**Response to Request for  
Additional Information -  
ANP-10337 Supplement 1**

ANP-10337  
Supplement 1Q2NP  
Revision 0

Topical Report

The United States Nuclear Regulatory Commission (NRC) provided a request for additional information (RAI) regarding the topical report ANP-10337PA, Supplement 1P-0 (Reference 1) in Reference 2. A total of 11 questions were received from the NRC.

**Figure 4-1 Illustration of Primary and Secondary Stress**

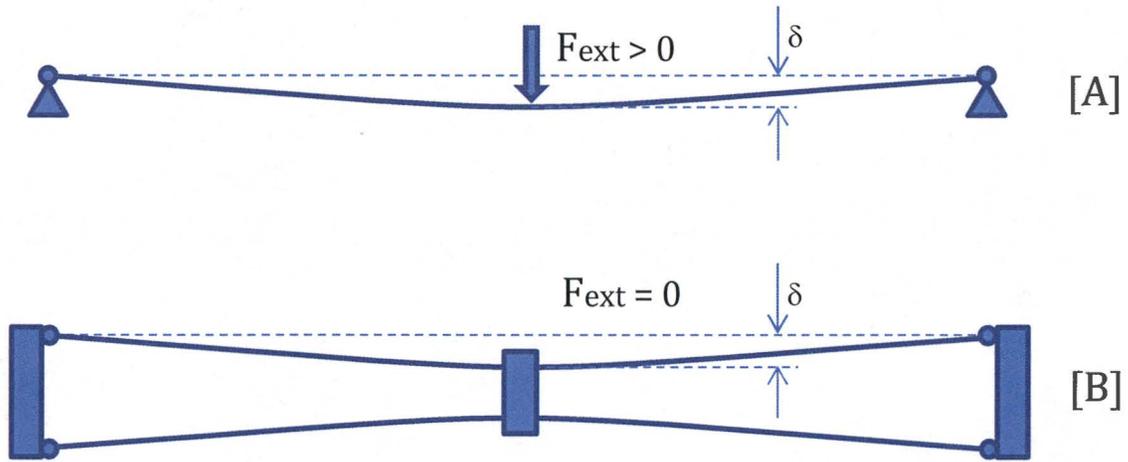
The essential difference between primary and secondary stress is that primary stresses are necessary to maintain equilibrium with external loads, while secondary stresses are present due to the self-constraint of the structure, and are associated with an imposed strain pattern. To illustrate this point, consider the case of a beam on pinned supports (Figure 4-1-A). In this case the external force  $F_{ext}$  creates a displacement  $\delta$  and a state of stress which is **necessary to maintain the equilibrium** with the applied external force. This stress is not equilibrating within the structure, nor is it self-limiting. If the external force increases, the stress has to increase as well in order to maintain equilibrium, and if the beam material yields though the section, the structure collapses. This case illustrates a typical primary stress. In Figure 4-1-B, the structure is composed of two beams and the same displacement  $\delta$  is applied in opposite directions by a restraining device. In this case the beams experience the same state of stress as in case A, but these stresses are equilibrating within the structure. The structure is in equilibrium under zero external force, hence these stresses are not needed to maintain equilibrium with external forces, but arise from the self-constraint of the structure, which is forced to comply with an imposed displacement pattern. This case illustrates a typical secondary stress.
